**30-039-22451 CANYON LARGO UNIT #301**  
**HILCORP ENERGY COMPANY**

HILCORP ENERGY COMPANY  
CANYON LARGO UNIT 301  
P&A NOI

Re: Permanent Abandonment  
Well: Canyon Largo Unit 301

**CONDITIONS OF APPROVAL**

**CANYON LARGO UNIT 301 - PROPOSED WELLBORE SCHEMATIC**

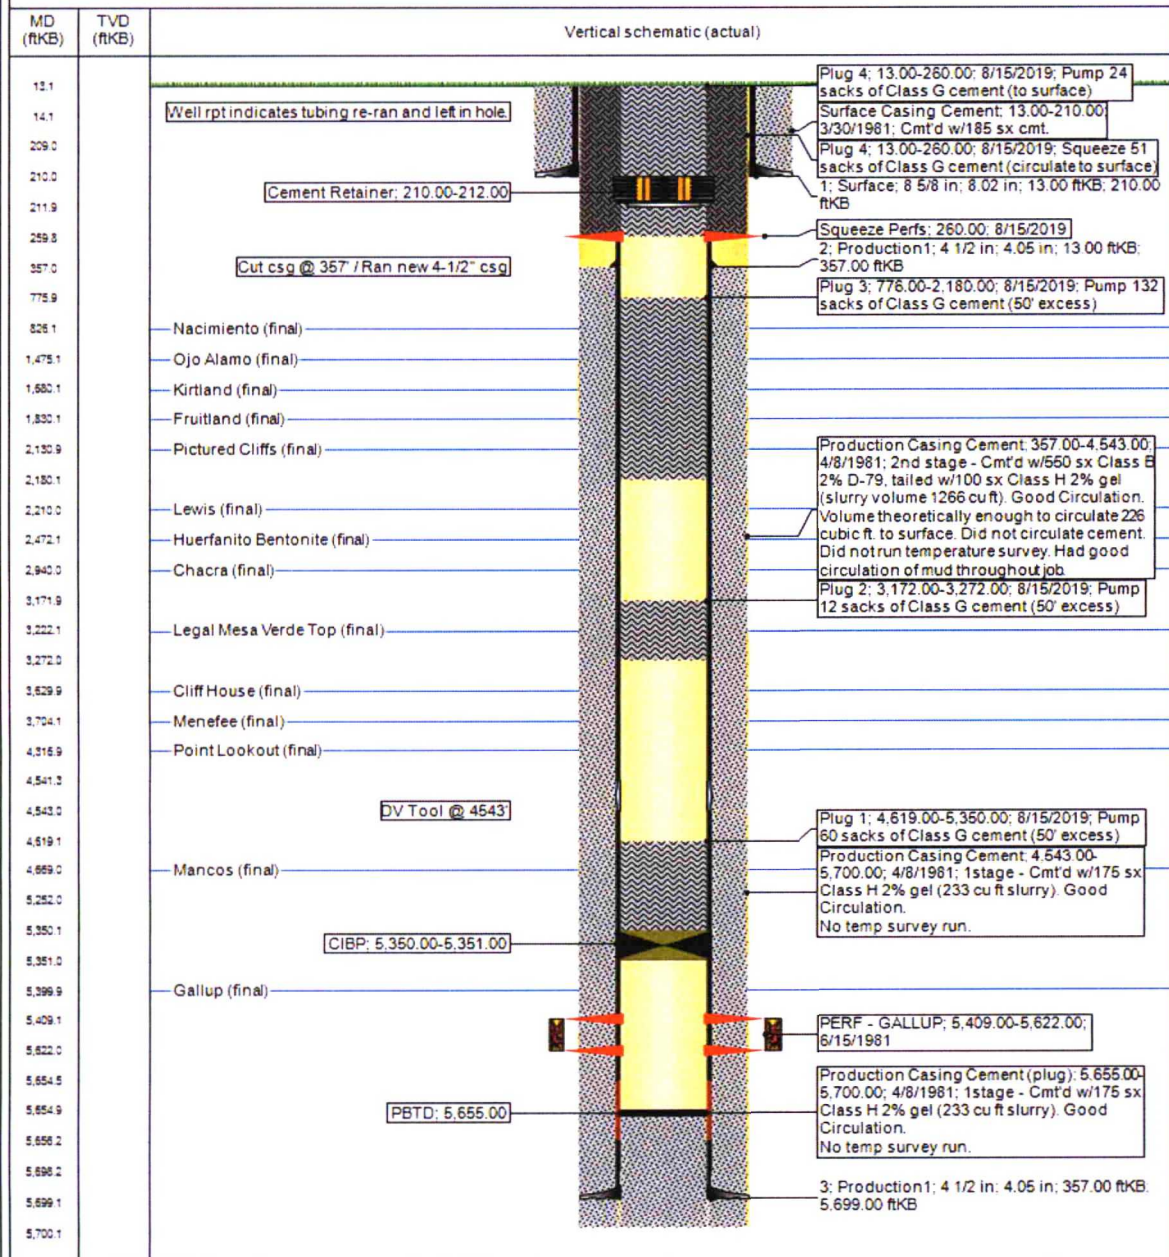
- Notify NMOCD 24hrs prior to beginning operations.
- Add Chacra Plug 2990'-2890'. OCD Chacra top: 2940'

1. Plugging operations authorized are subject to the attached "General Requirements for Permanent Abandonment of Wells on Federal and Indian Lease."
2. Farmington Office is to be notified at least 24 hours before the plugging operations commence (505) 564-7750.
3. Submit electronic copy of the CBL for verification to the following addresses: [jkillins@blm.gov](mailto:jkillins@blm.gov) and [Brandon.Powell@state.nm.us](mailto:Brandon.Powell@state.nm.us) . Based on CBL results inside/outside plugs and volumes will be adjusted accordingly. Please review the General Requirements document to ensure volumes meet required excess inside and outside casing.
4. Add an additional plug (3,580'-3,680') to cover Cliffhouse top at 3,630'.
